17075-18

RE: Re: Transmittal of Response to U.S. EPA Comments on the Phase 1B RFI Work Plan  
Amendment, Saginaw Metal Casting Operations, U.S. EPA ID No MID 041-793-340

## Response to U.S. EPA Electronic Comments on GM's Phase 1B RFI Work Plan Amendment

FORMER PARTS PLANT AREA  
GENERAL MOTORS CORPORATION  
SAGINAW METAL CASTING OPERATIONS  
*Saginaw, Michigan*

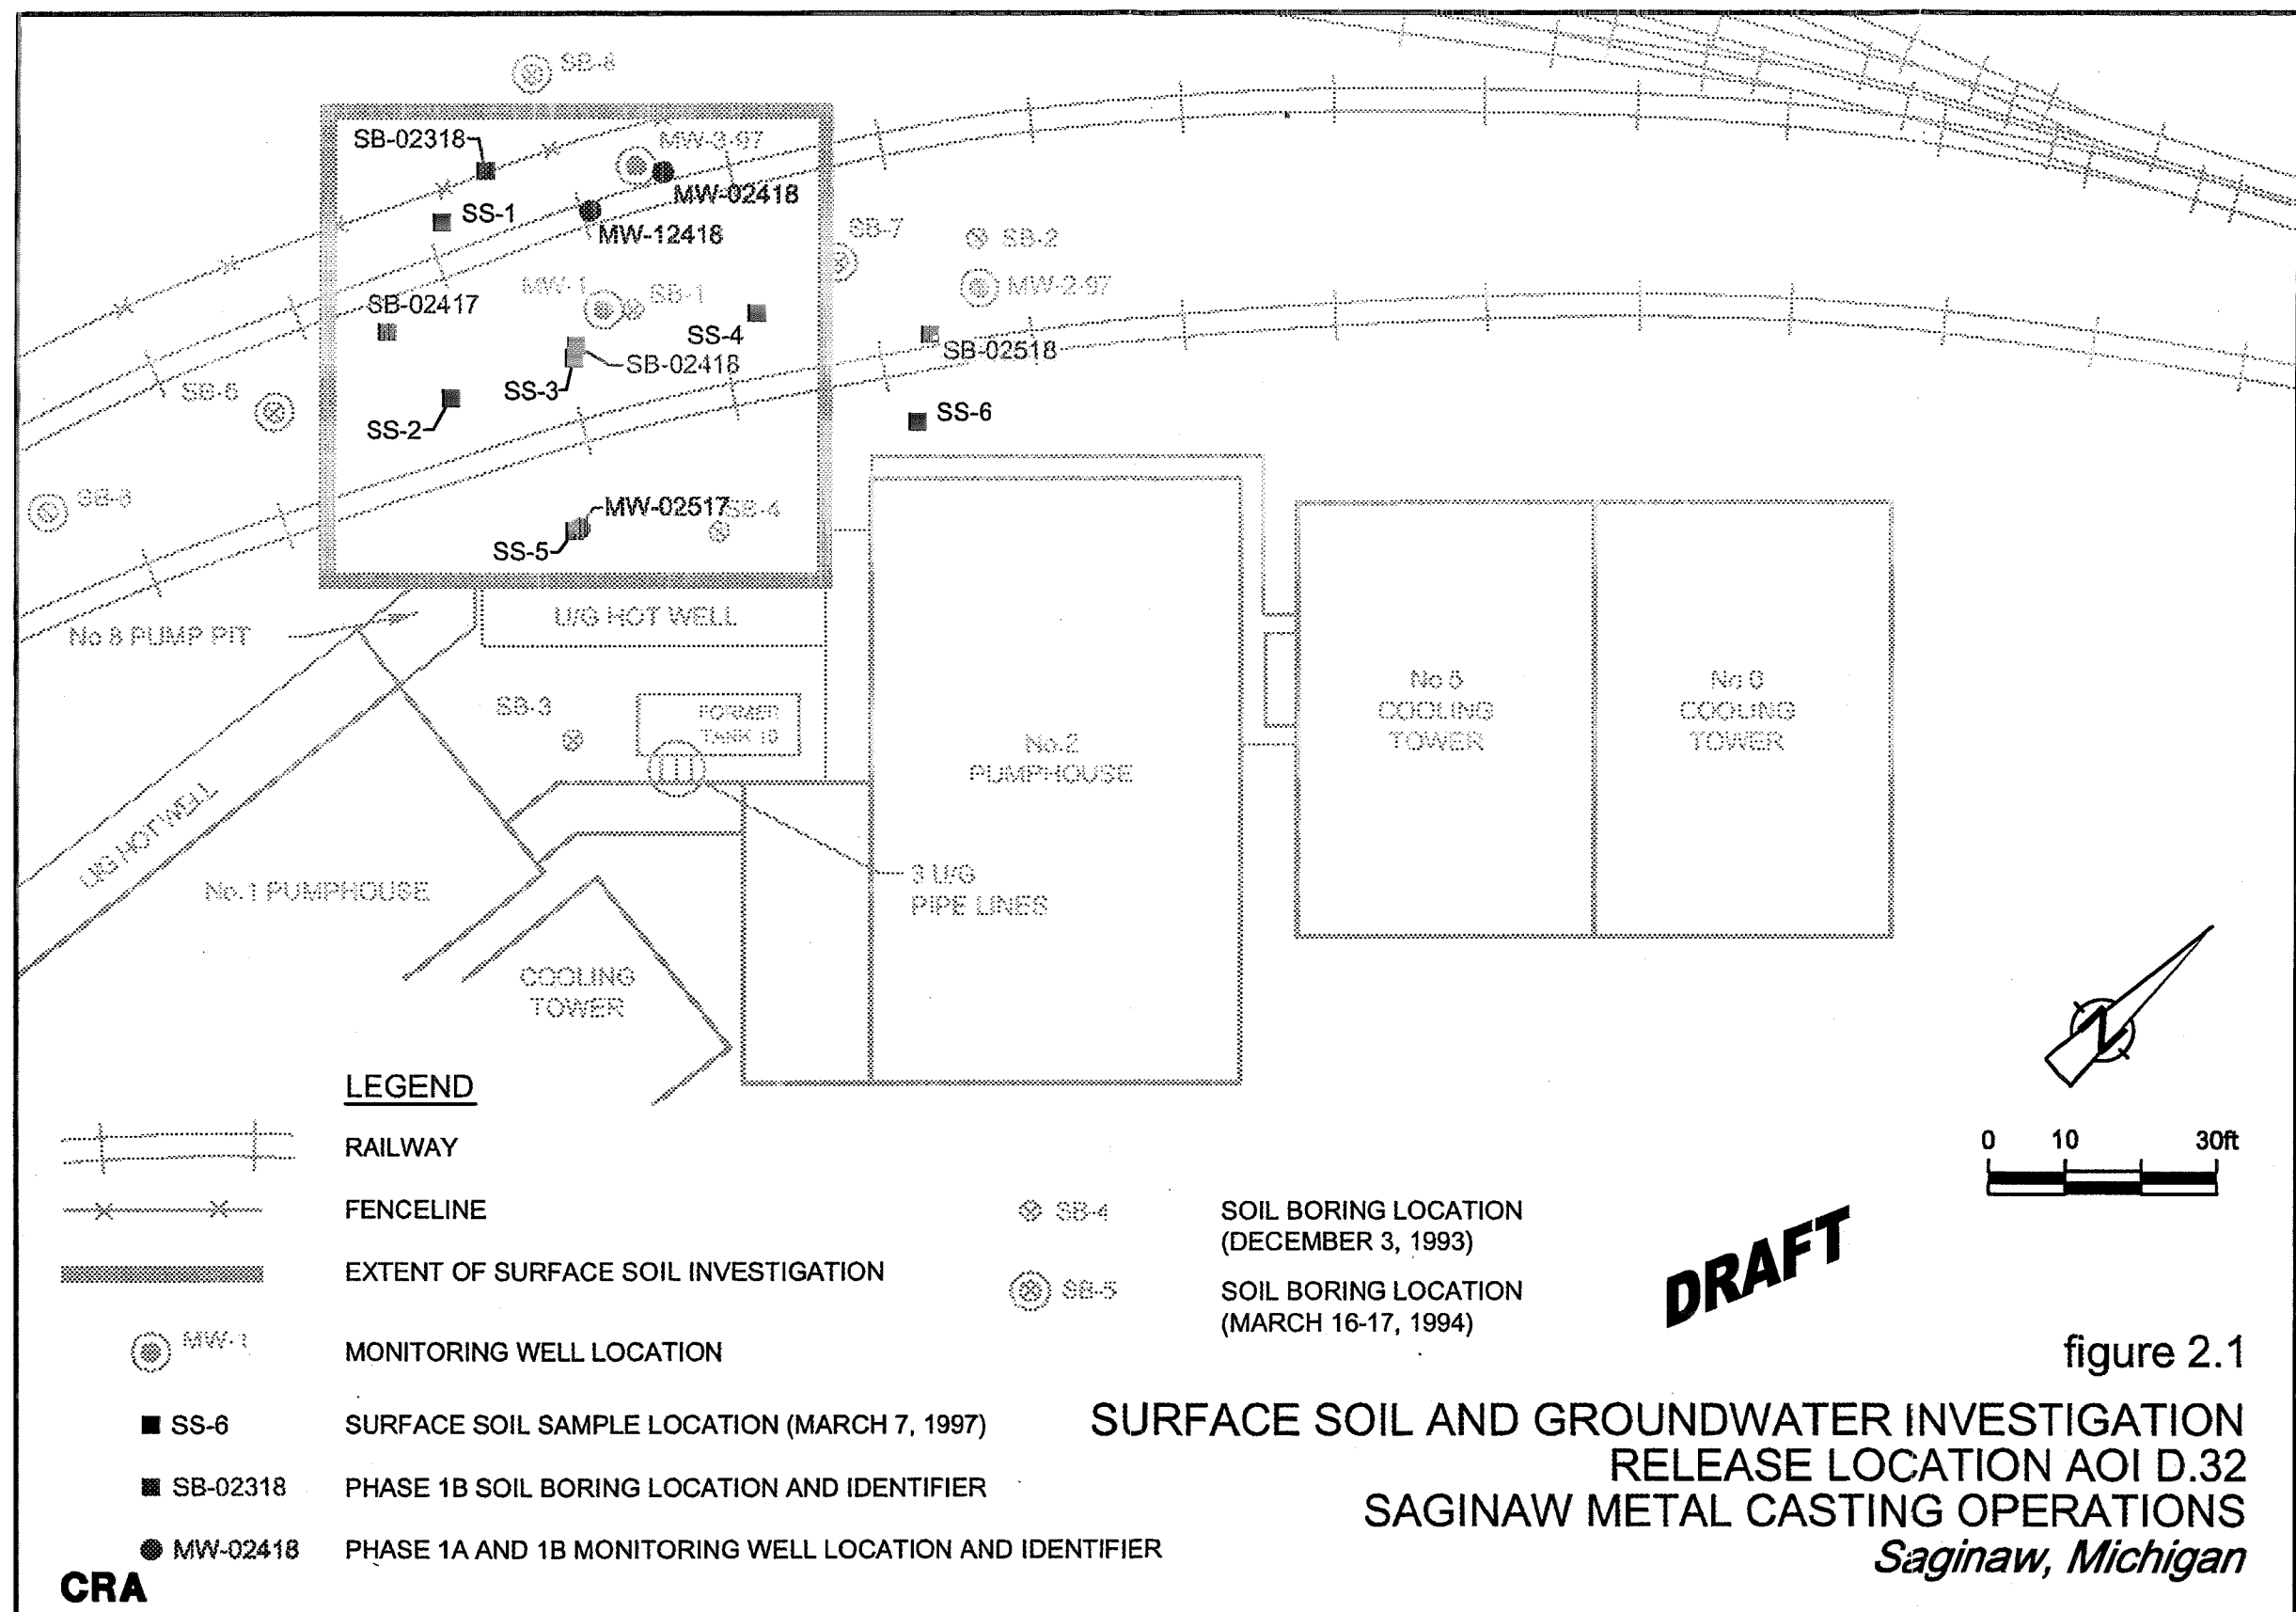
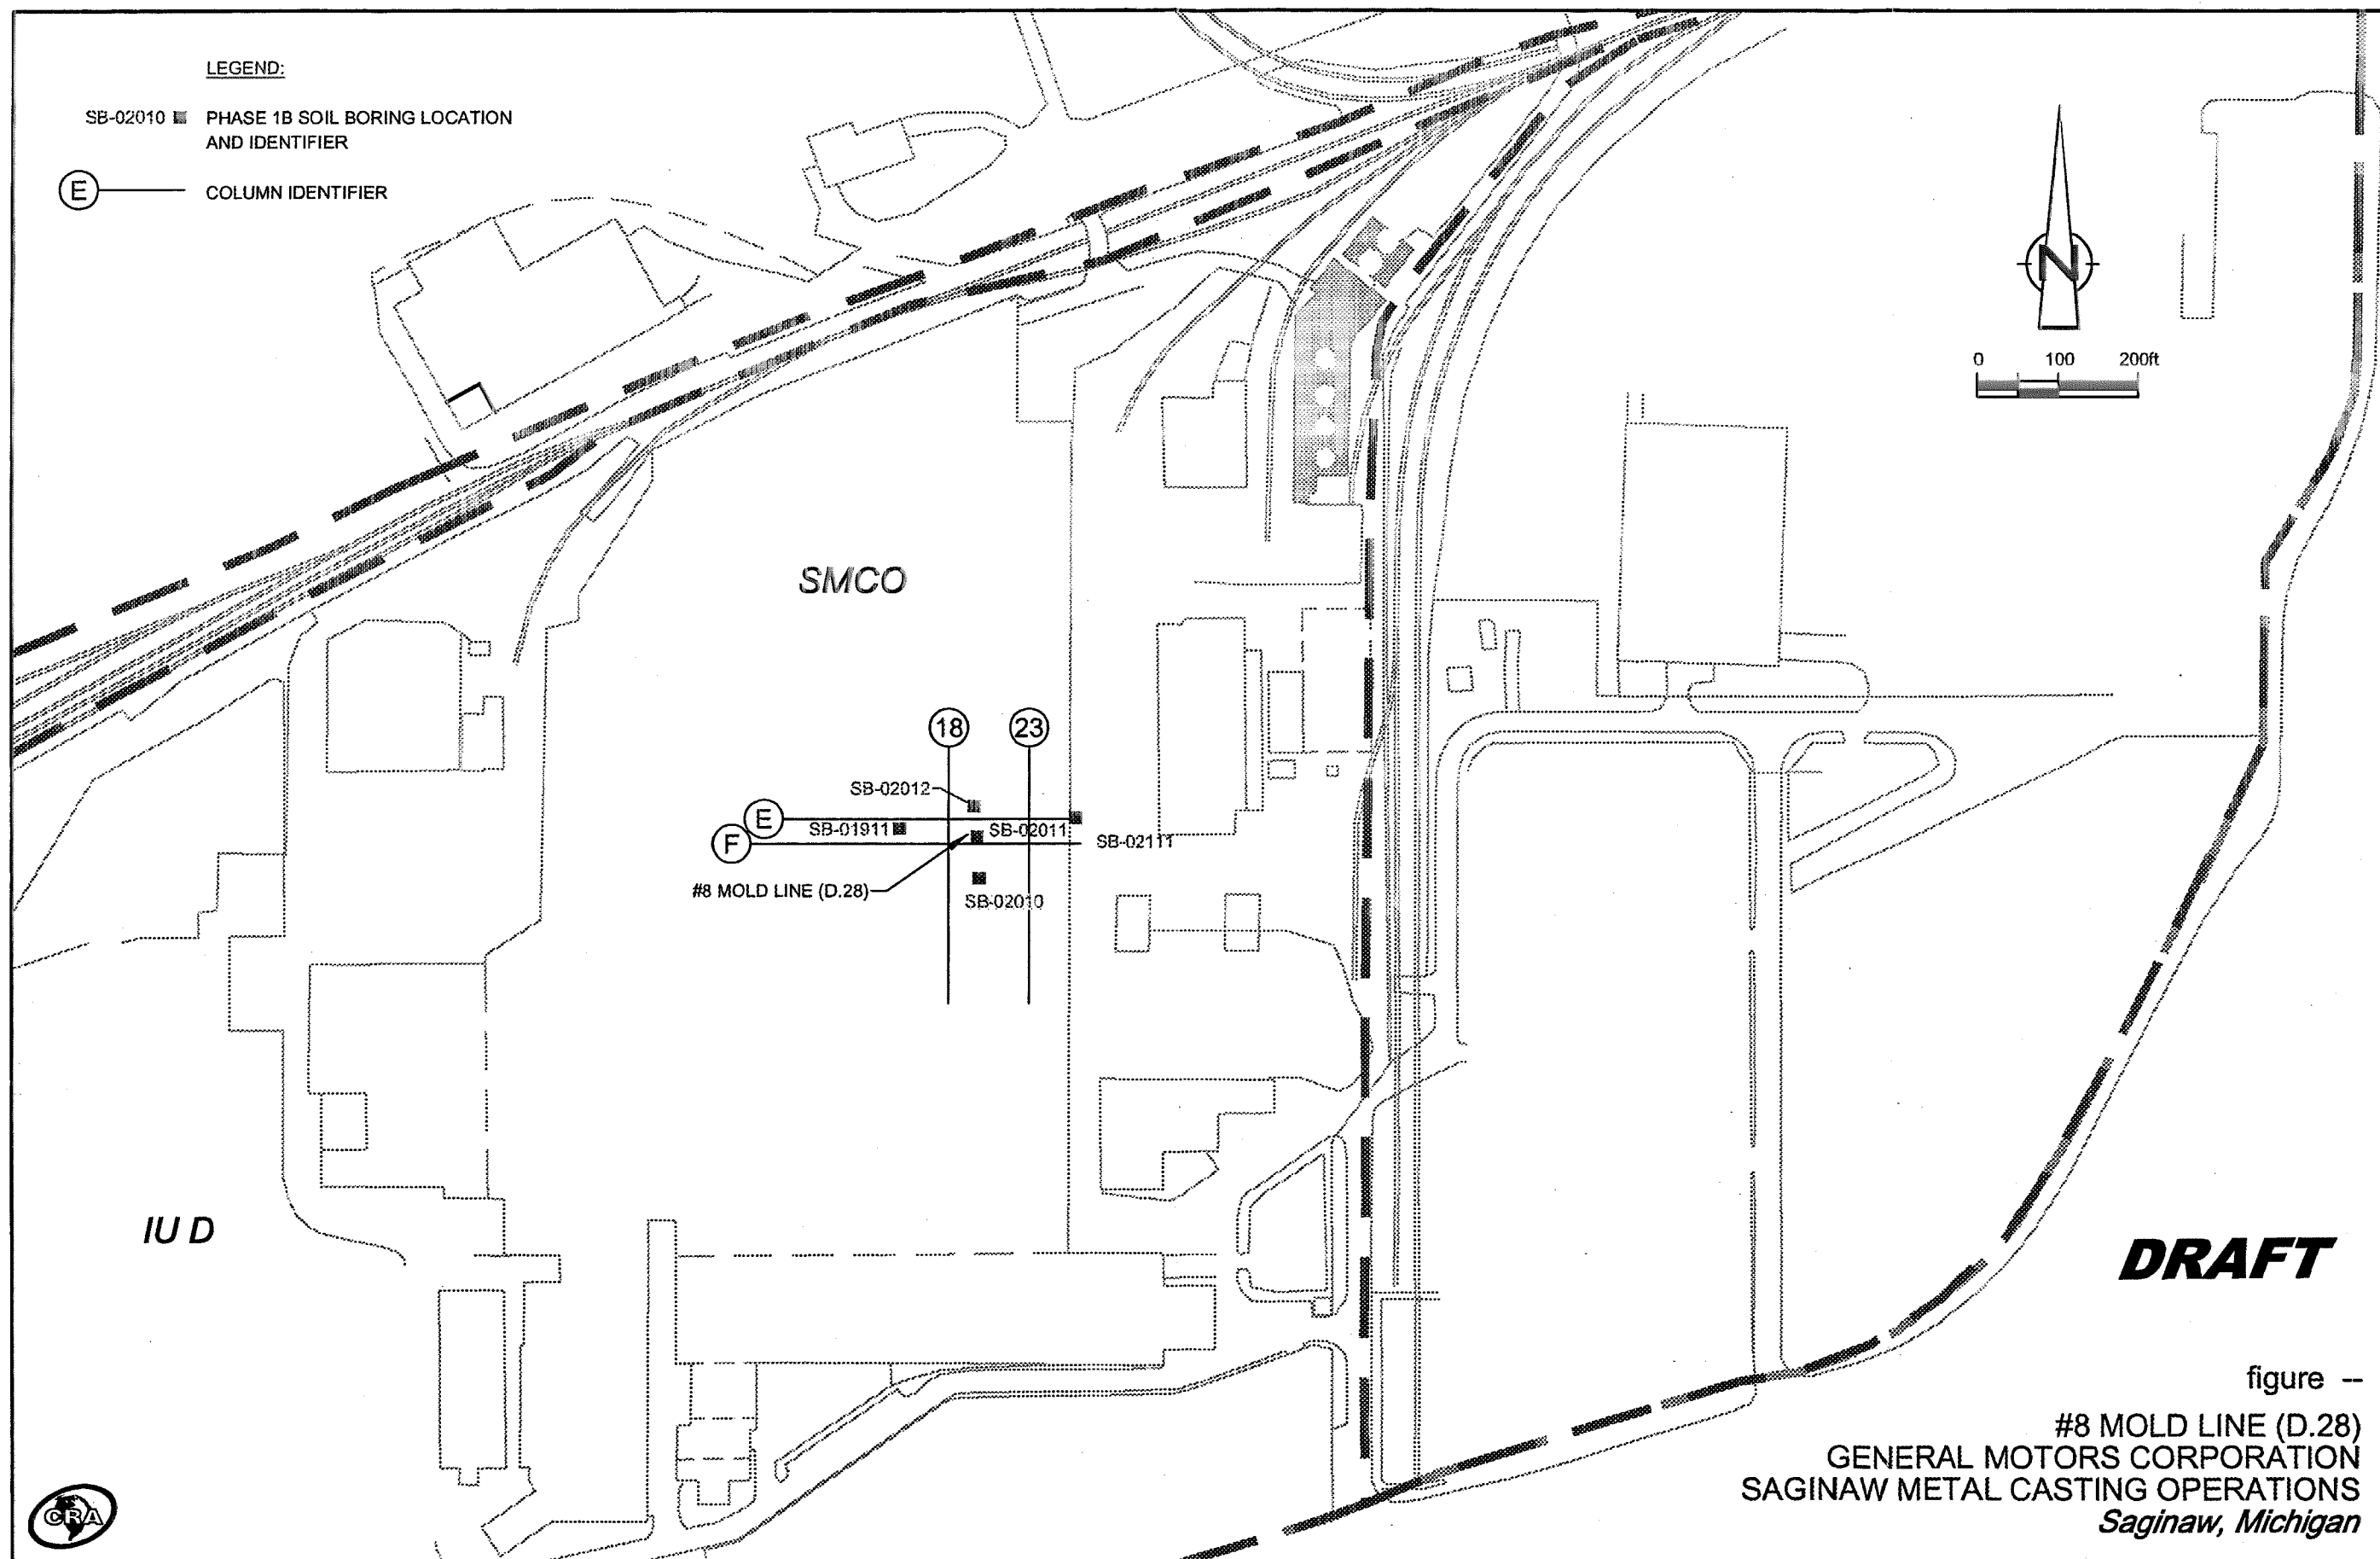
**b) Soil characterization for lead appears warranted due to SLE for lead at SB-00508.**

*Numerous soil samples have been collected within the northern portion of Investigative Unit B (March 9, 2000, Monthly Progress Report and February 8, 2001, Monthly Progress Report). Sample results for total lead are tabled below (refer to the attached Figure for IU B for sample locations). These samples which have been submitted to the U.S. EPA show that the Phase 1B Screening Level exceedances of lead in soil in this area have been sufficiently defined. However, lead will be added to the analyte list for soil samples collected from the proposed borings located to the east of SB-00508.*
